Staff Report

To: Salt Lake City Historic Landmark Commission
From: Lex Traughber – Senior Planner
(801) 535-6184 or lex.traughber@slcgov.com
Preston Larson – Planning Intern
Date: March 1, 2018
Re: Petition PLNHLC2017-00941, 690 N. West Capitol Street – New Construction
Petition PLNHLC2018-00096 - 690 N. West Capitol Street – Special Exception

NEW CONSTRUCTION IN A HISTORIC DISTRICT

STERLING ON CAPITOL HILL

D201

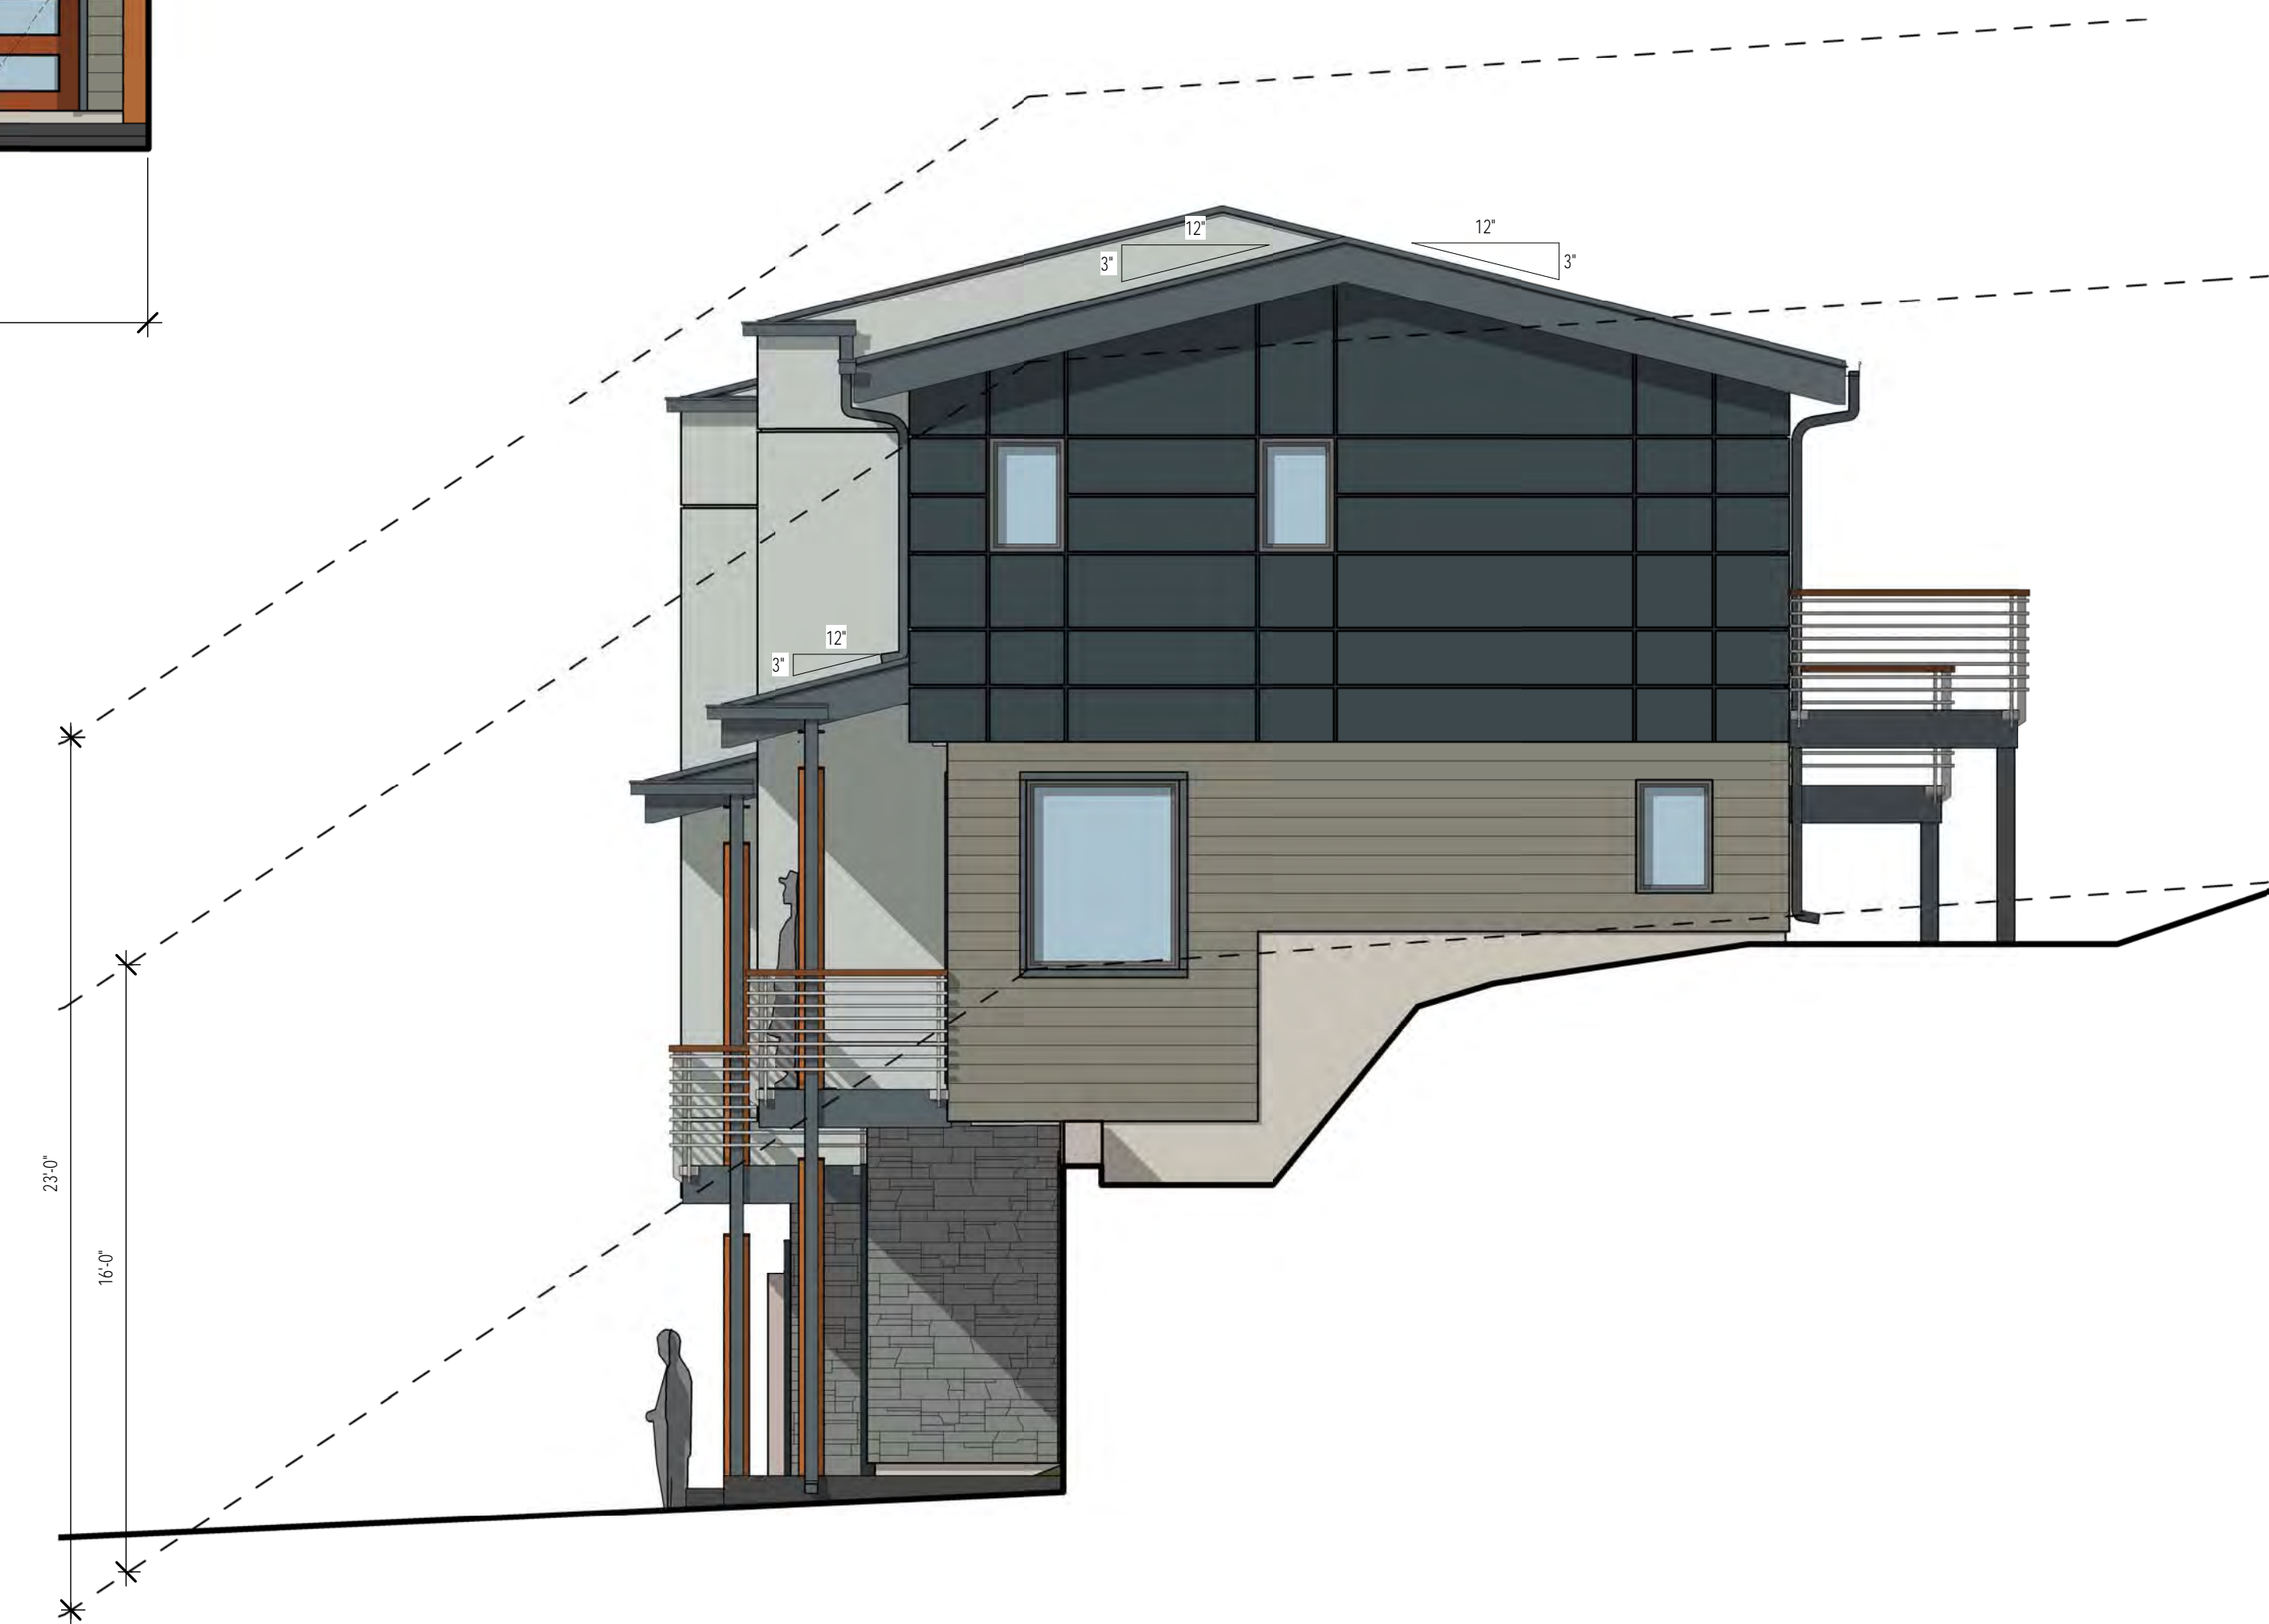
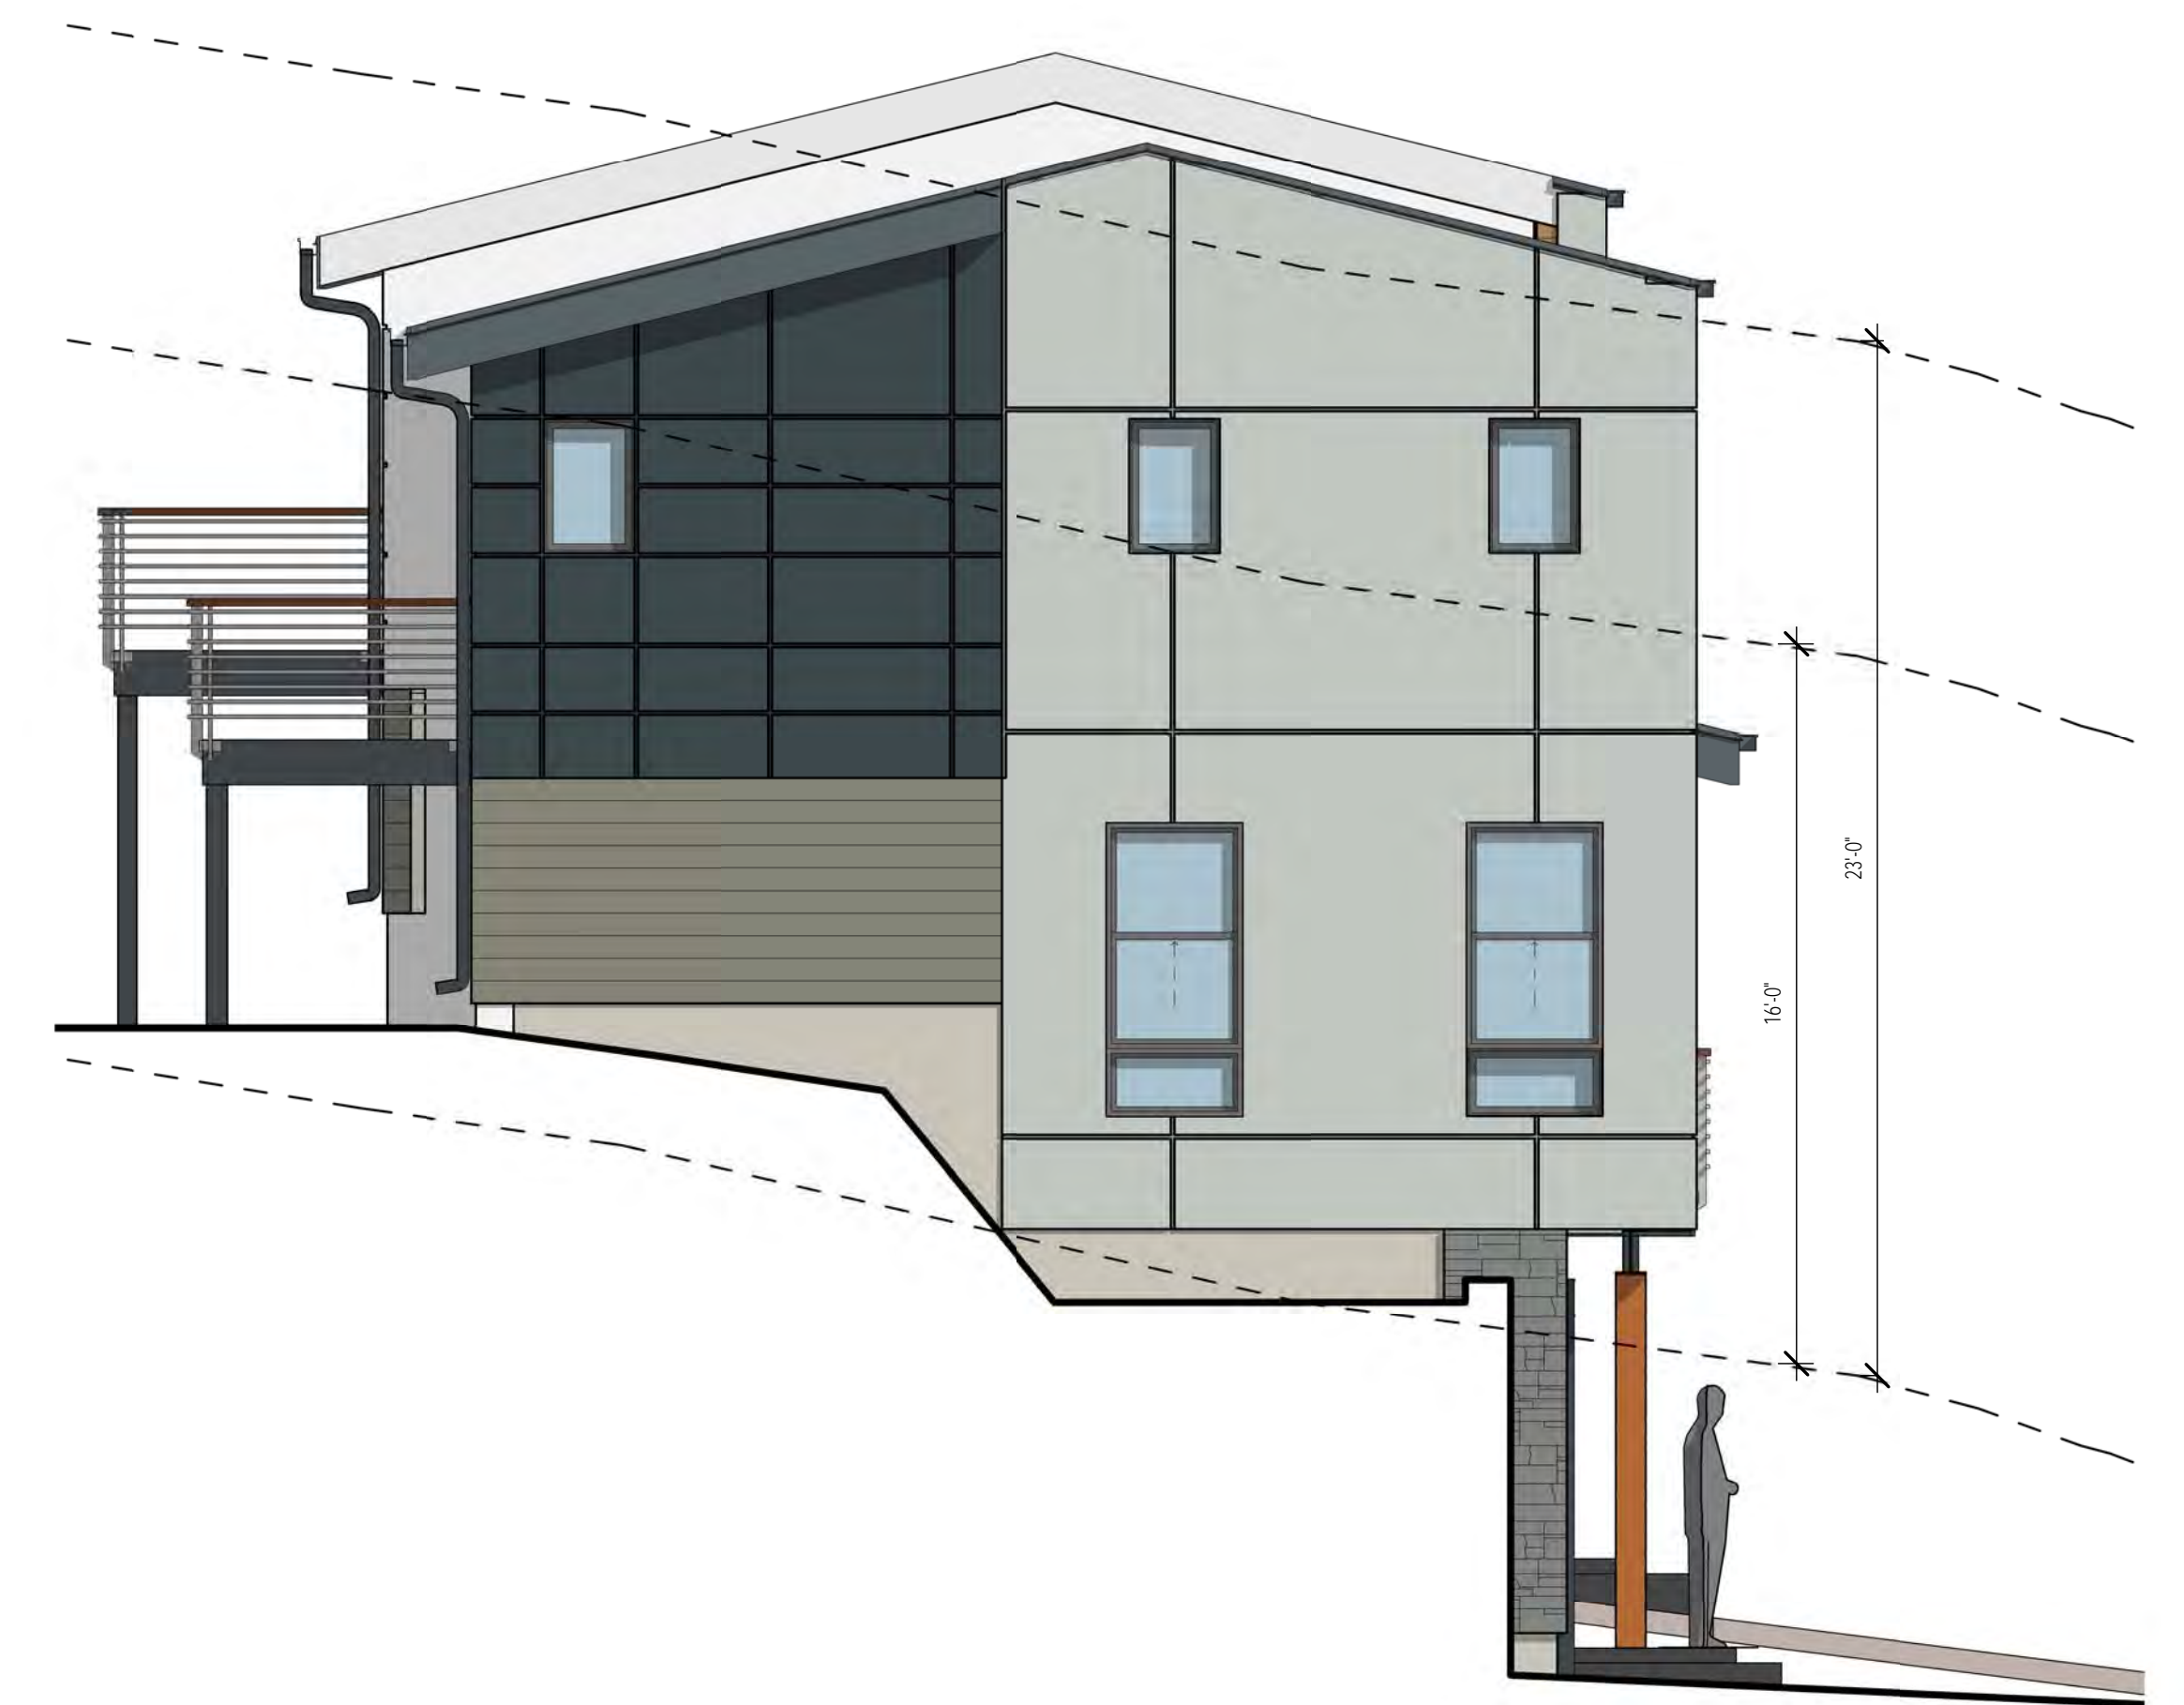
- 3) Will need to address building height that exceeds the maximum 16 feet for flat roof structures.

The revised plans now show pitched roofs with a 3:12 slope instead of the flat shed roofs on the previous submittal. However, the majority of the dwellings still exceed the maximum 23 feet height limitation and the 16 feet wall height limitation and will require landmarks approval. The grade changes also exceed the maximum and will need to be addressed.

Answer: *Per zoning ordinance building height can be 23' for sloped roofs measured to ridge of roof or average height of other buildings on the block face. (21A.24.080-D-1-B). Building heights are measured from the established (existing) grade (21A.24.080-D-4). Per your previous comments, SLC allows for 2:12 pitched roofs to be classified as "pitched."*

C-100

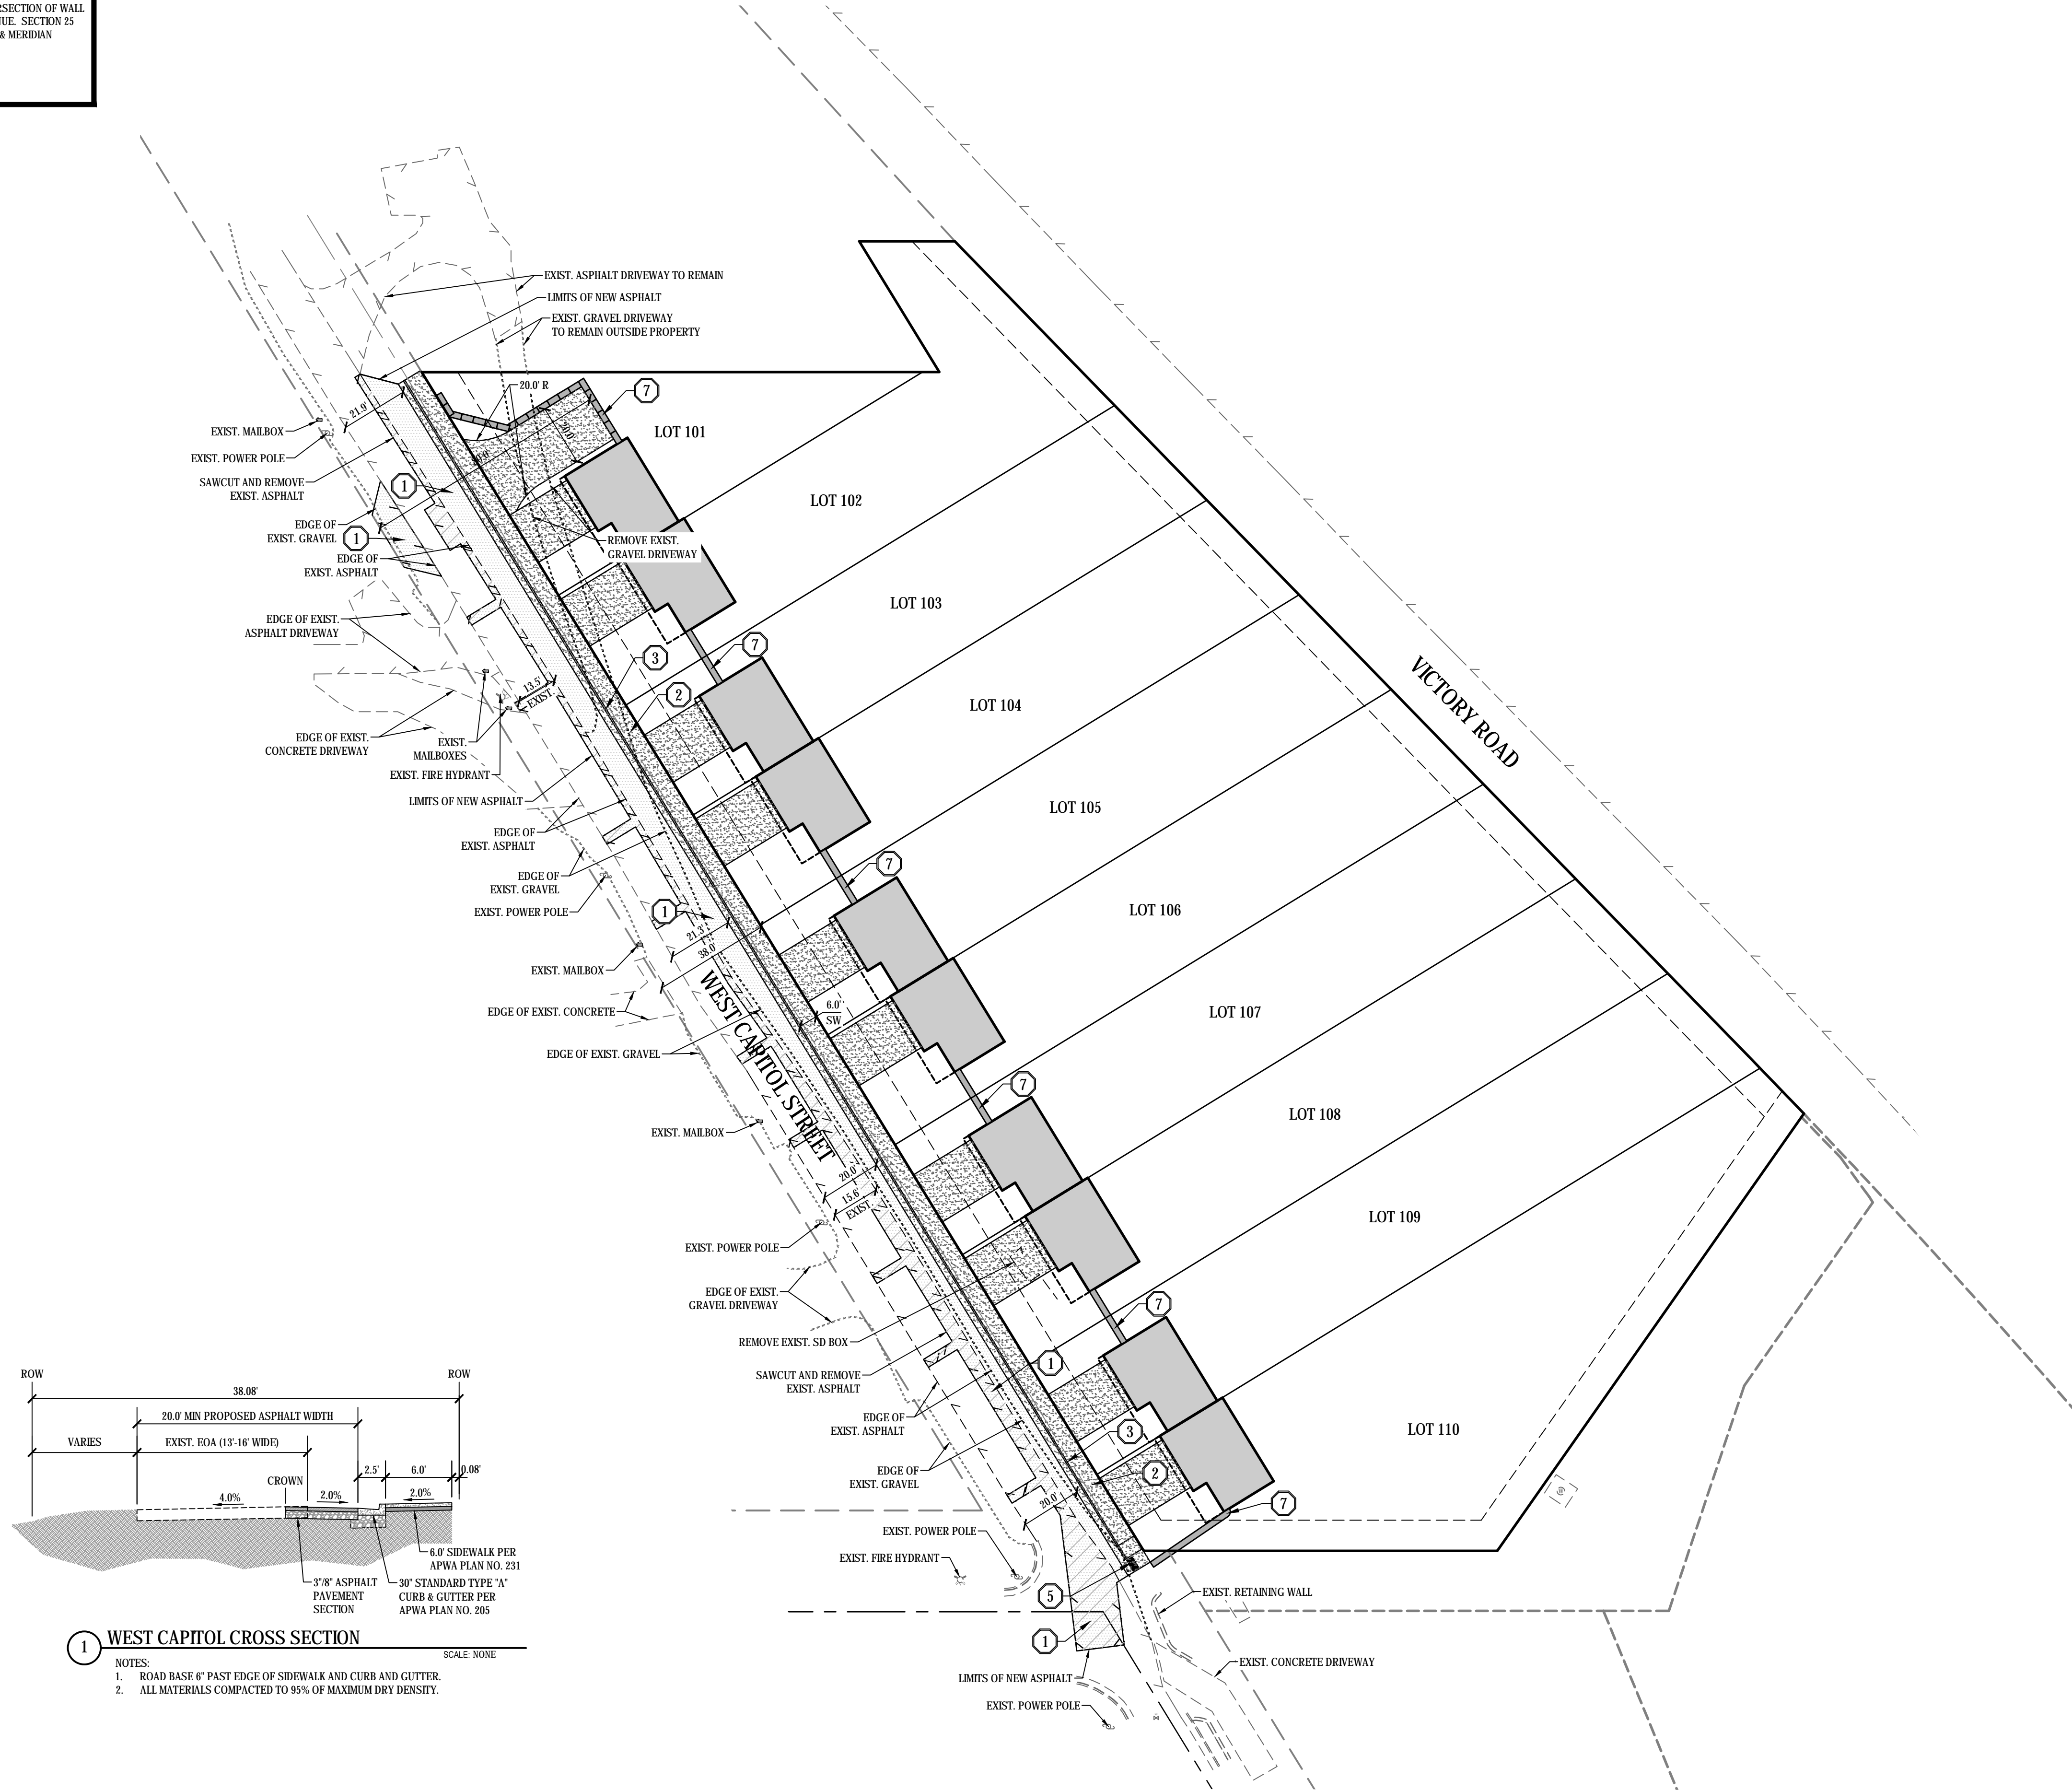
I'm attaching Ordinance 56 of 2016, listing the 11.5' vacation width. Do you know if the conditions of this ordinance were met? If they were, the width of West Capitol Street is no longer 50'. The cross section on Sheet C-100 shows the width as 38.0'. Perhaps the correct width is $50' - 11.5' = 38.5'$.
